CCK-2979.00-1-26

UK North Farm Seedhouse

ADDENDUM #4

UK Project #: 2979.0 Seedhouse

A402 ADD 4

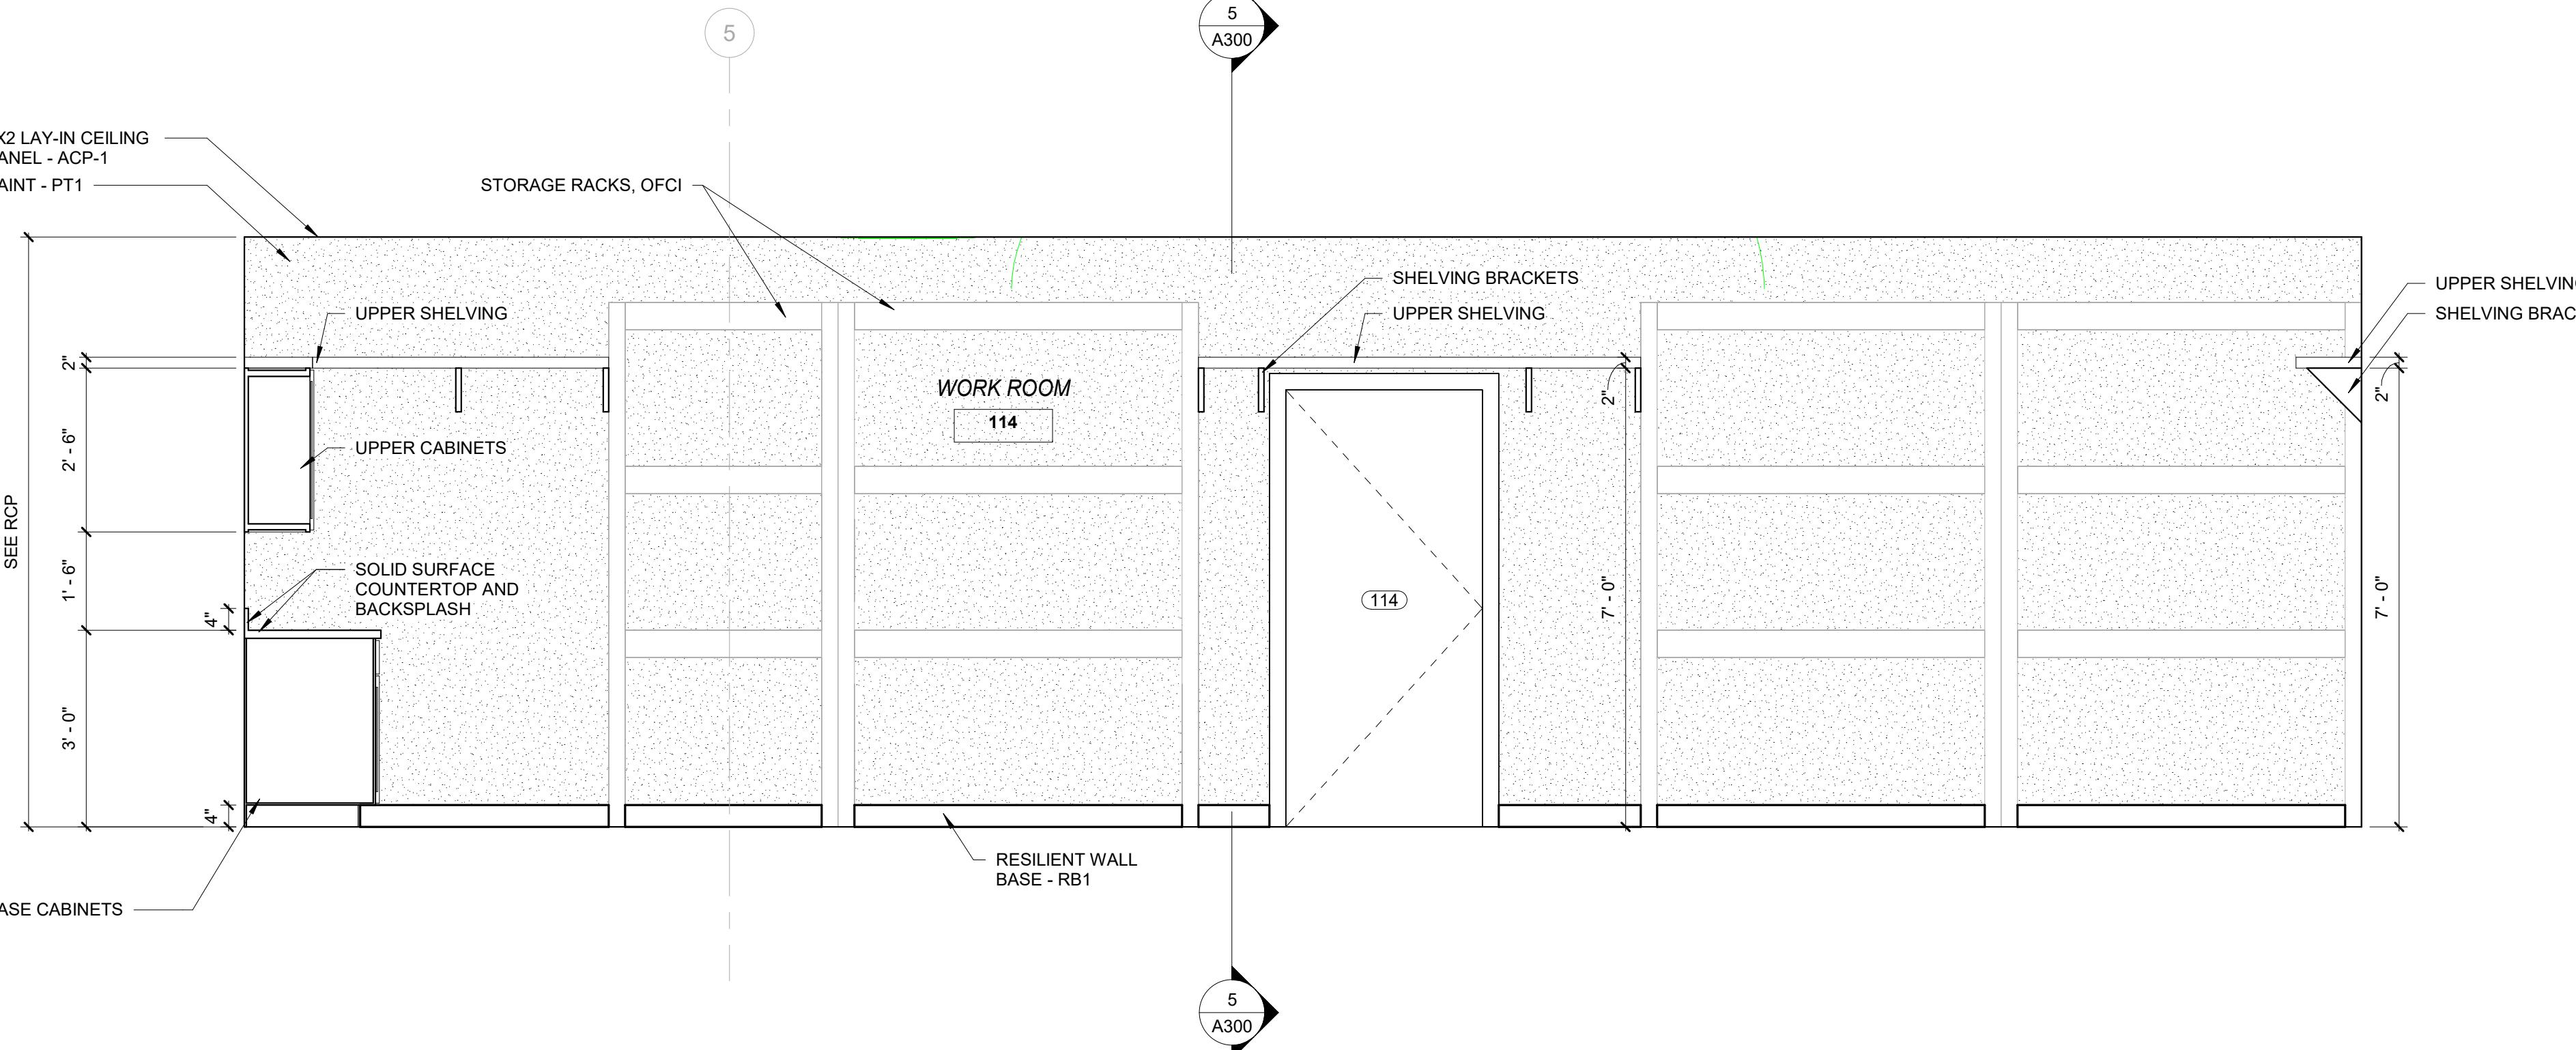
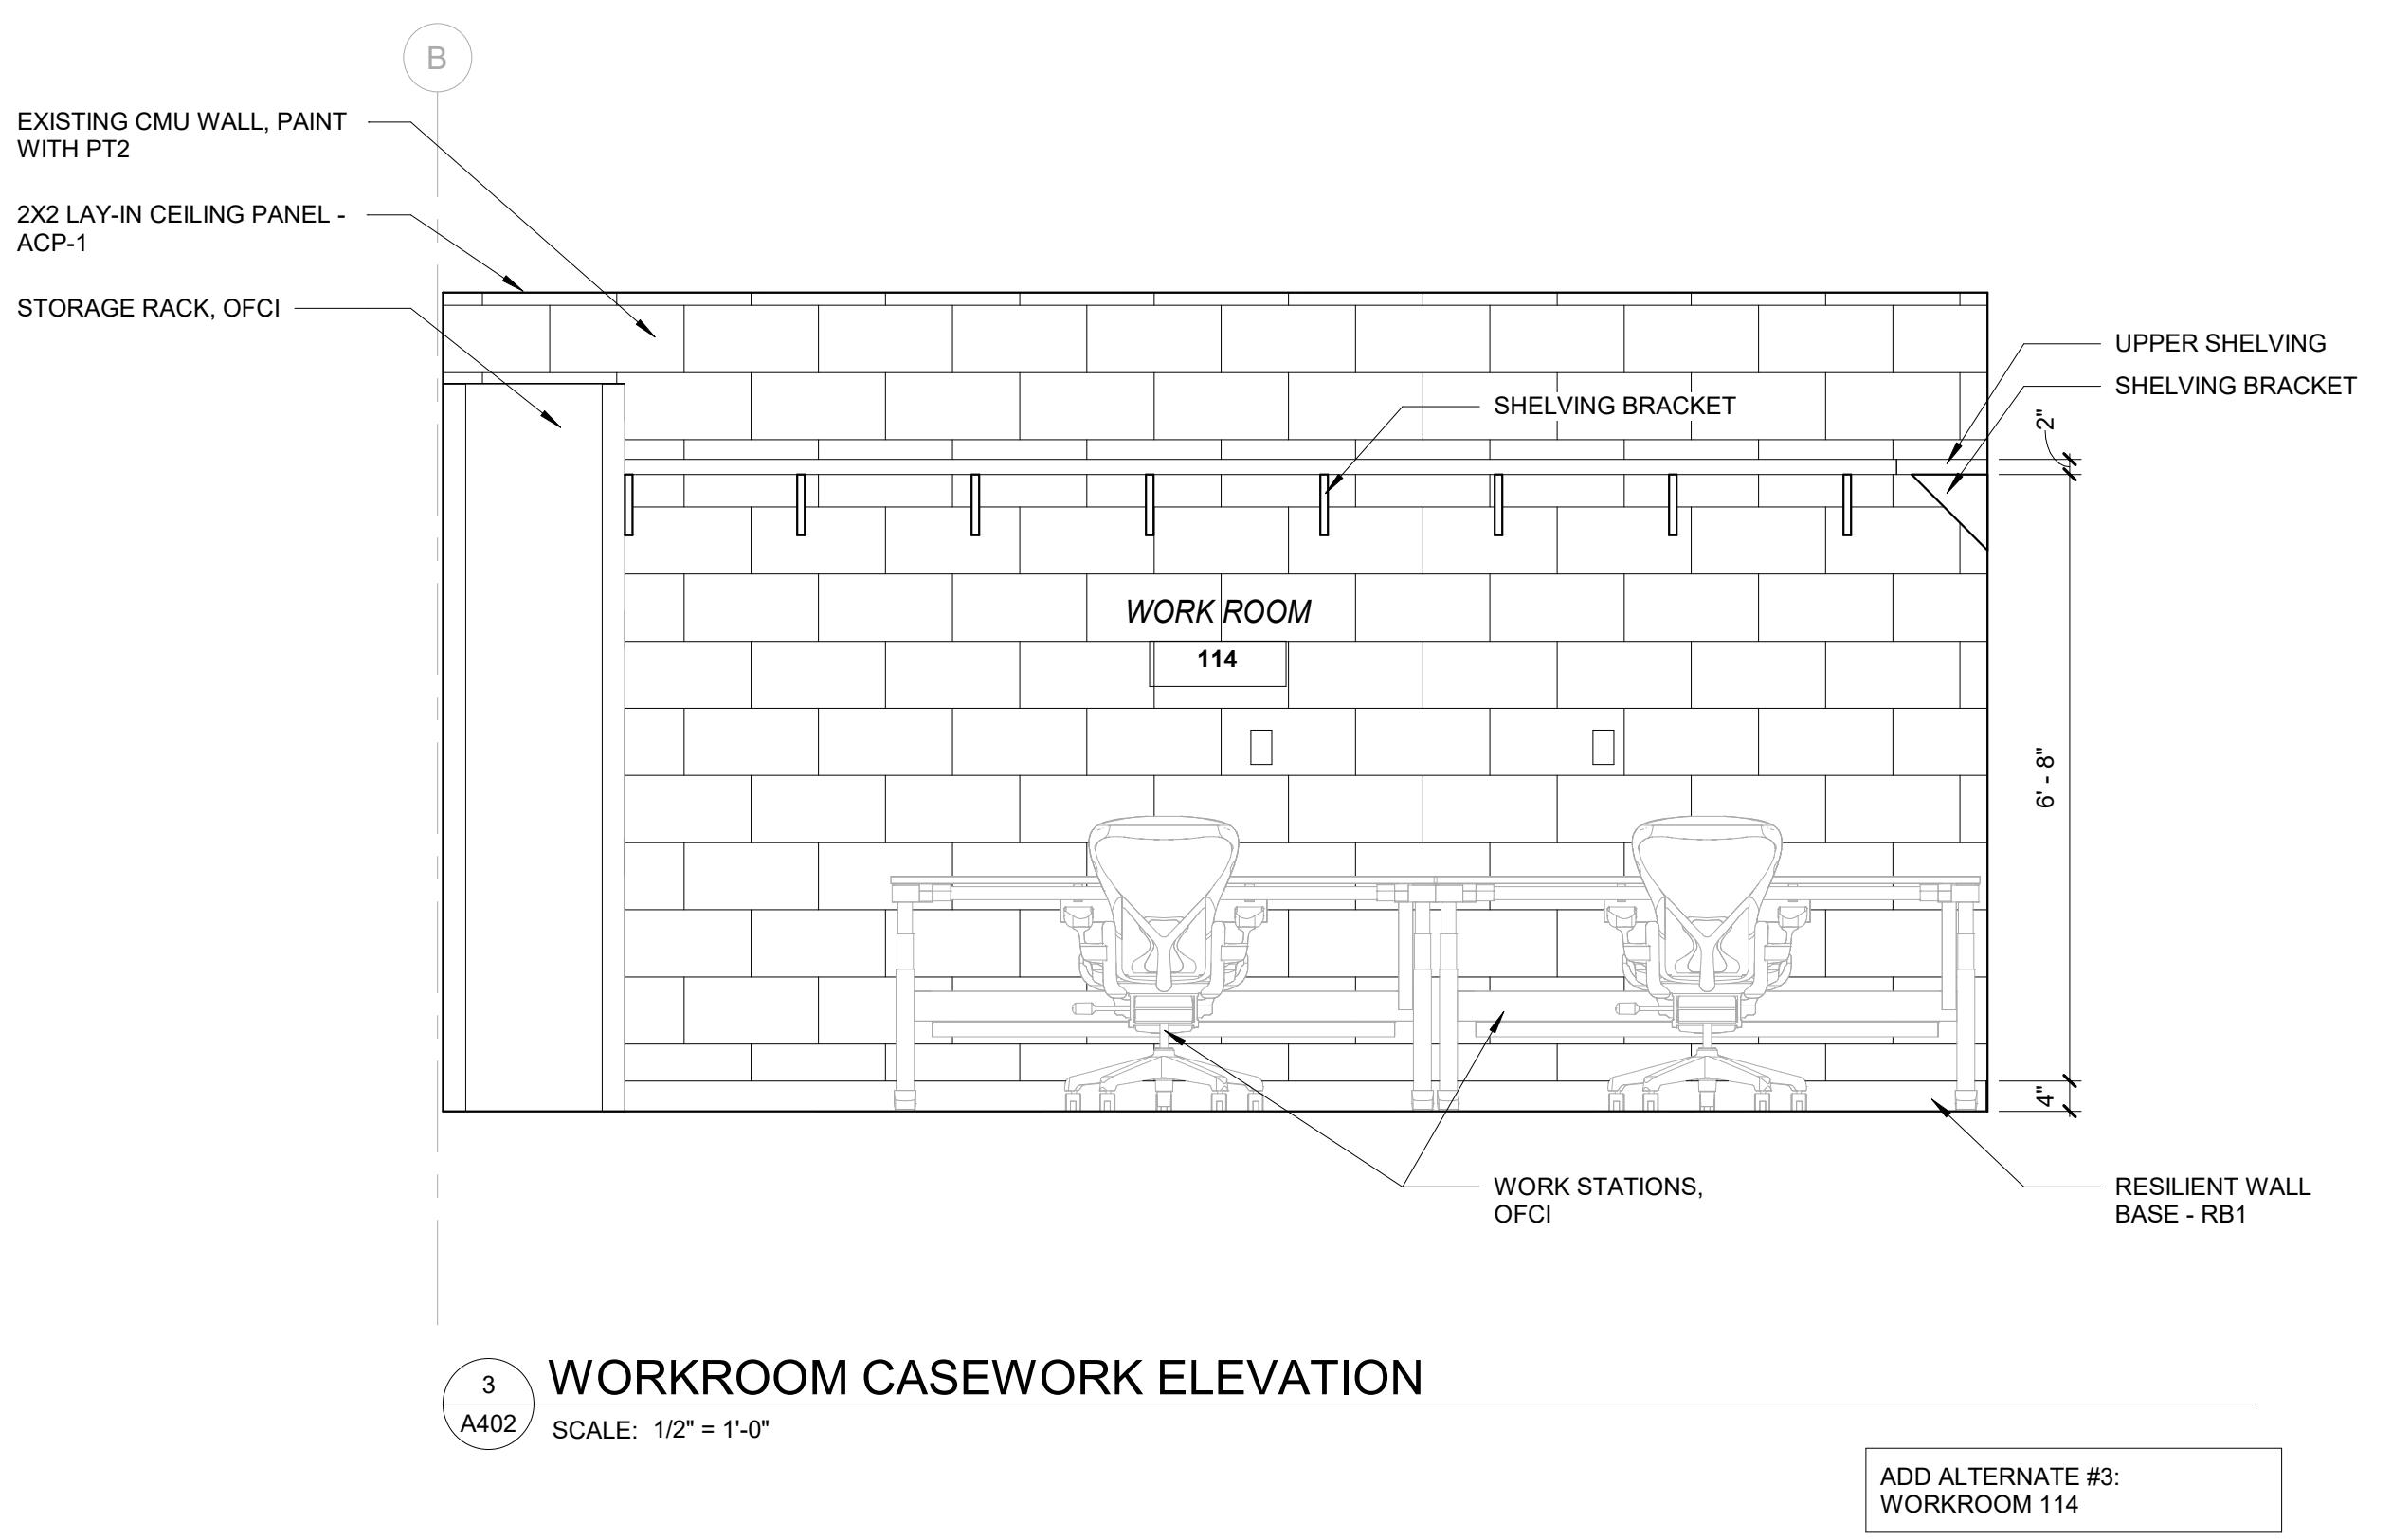
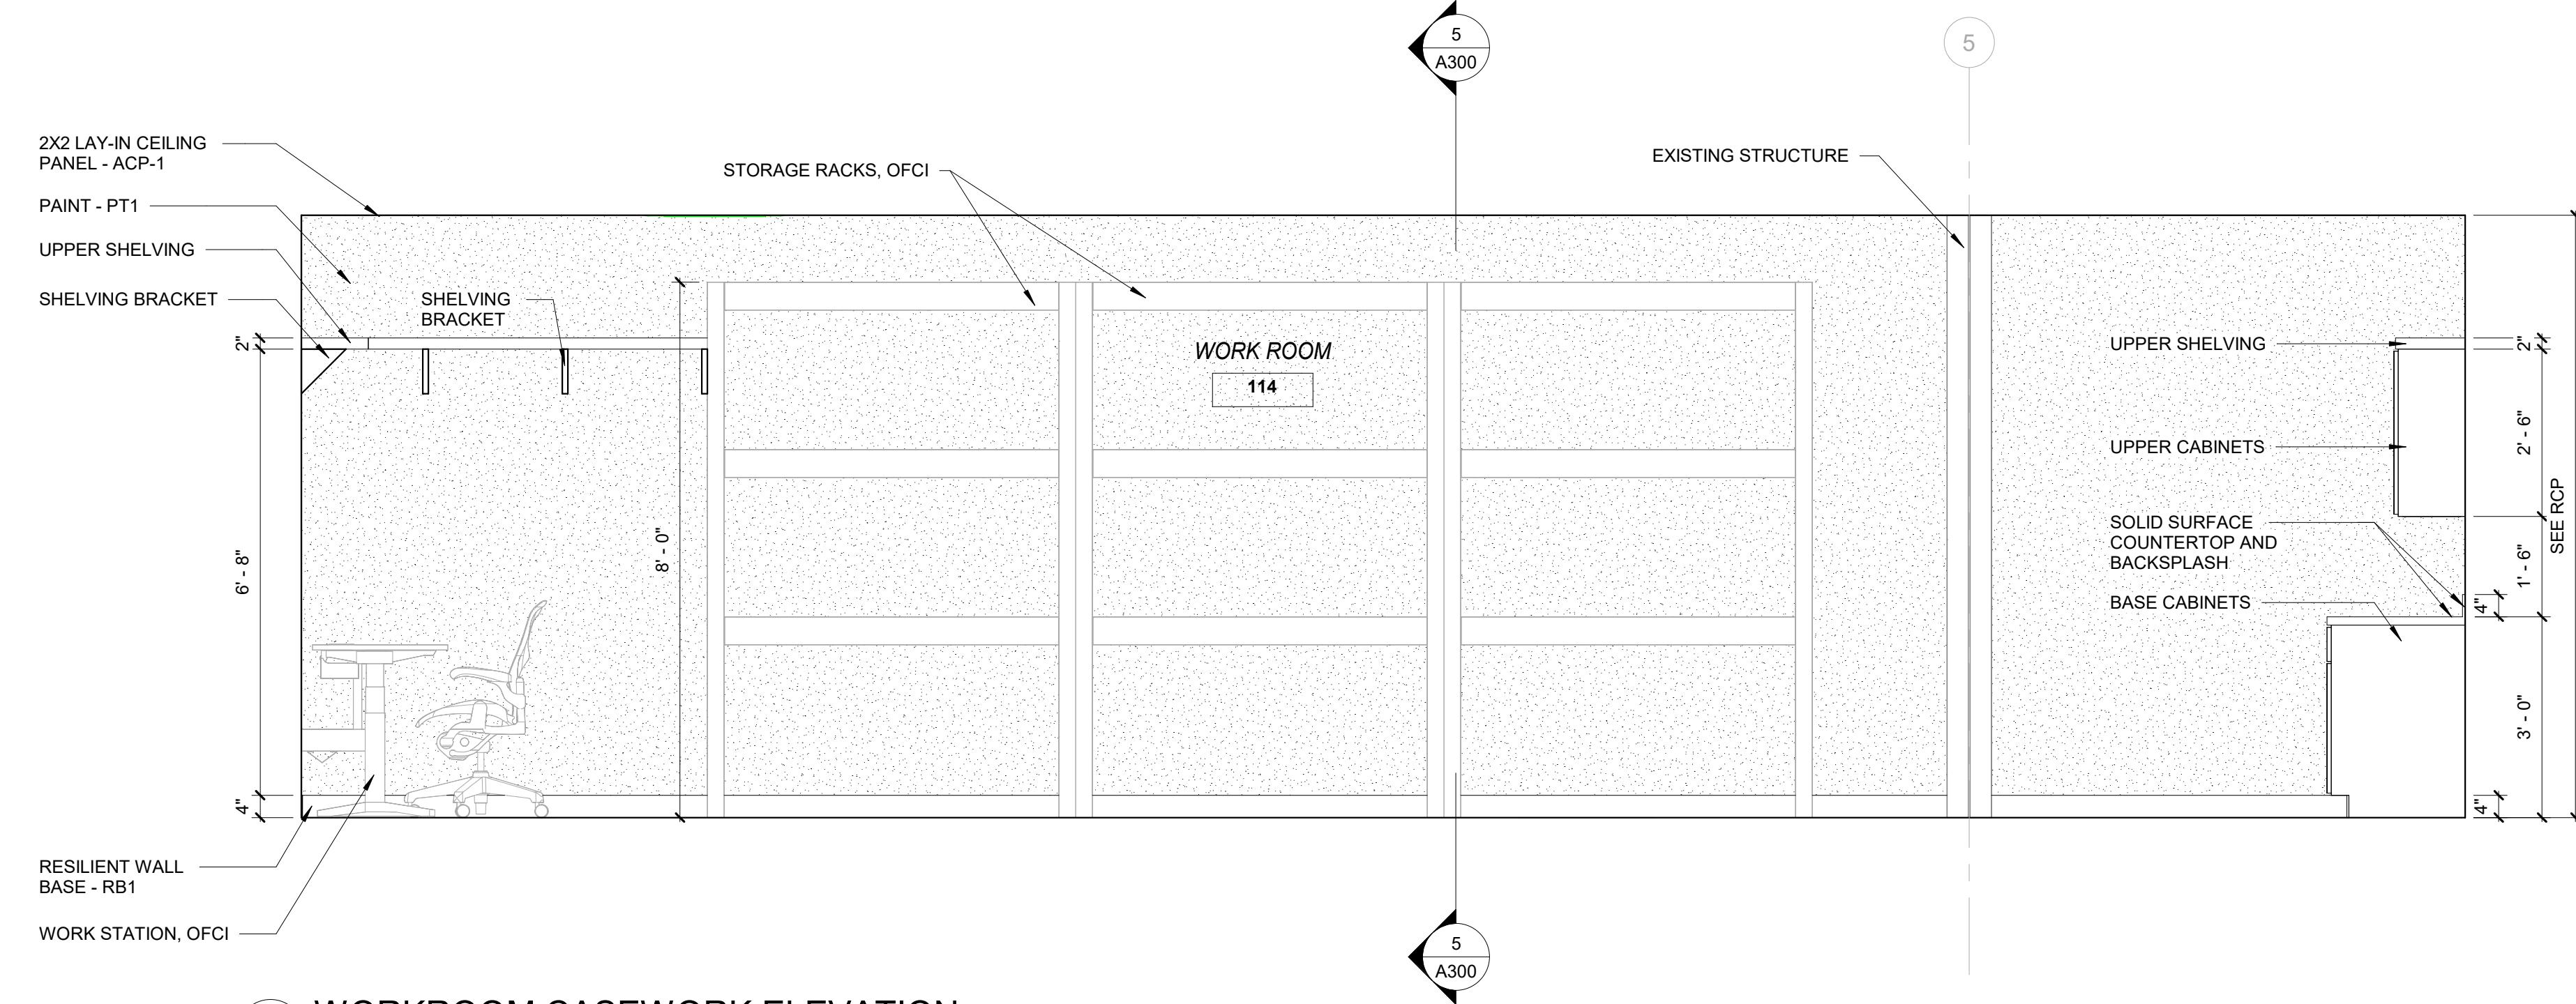
6. Refer to attached new sheet A402 – INTERIOR ELEVATIONS for added Interior Elevations for Work Room 114.
7. Refer to attached revised sheet A600 for finish selections and for updated Tile Base to rooms 106 and 119.

20	1/5/2026	Are there any elevations for workroom 114?	Morris Workshop	Refer to attached revised sheet A400 and added sheet A402	Addendum #4 - 1/29/2026
21	1/5/2026	What mockups are required for our scope?	Morris Workshop	Approved color samples are sufficient and no casework mockup will be required.	Addendum #4 - 1/29/2026
22	1/8/2026	On the lighting plan, alternate #1 is shown as alternate #2, and alternate #2 is shown to be included as alternate #3. Can you clarify if this is correct or if we need to follow the alternates how it is shown on the power plans?	KFI	Alternates have been fixed accordingly. See attached revised sheets.	Addendum #4 - 1/29/2026
23	1/8/2026	Are we only replacing the bulbs in the fixtures shown on the upper level on sheet E202 or are we providing brand new fixtures?	KFI	Yes, bulb replacement only on the upper levels.	Addendum #4 - 1/29/2026
24	1/8/2026	Are we providing new lighting fixtures or bulbs on the 3rd level as well? The plans only show one upper level with a total of 7 fixtures.	KFI	All upper levels will only be a bulb replacement.	Addendum #4 - 1/29/2026
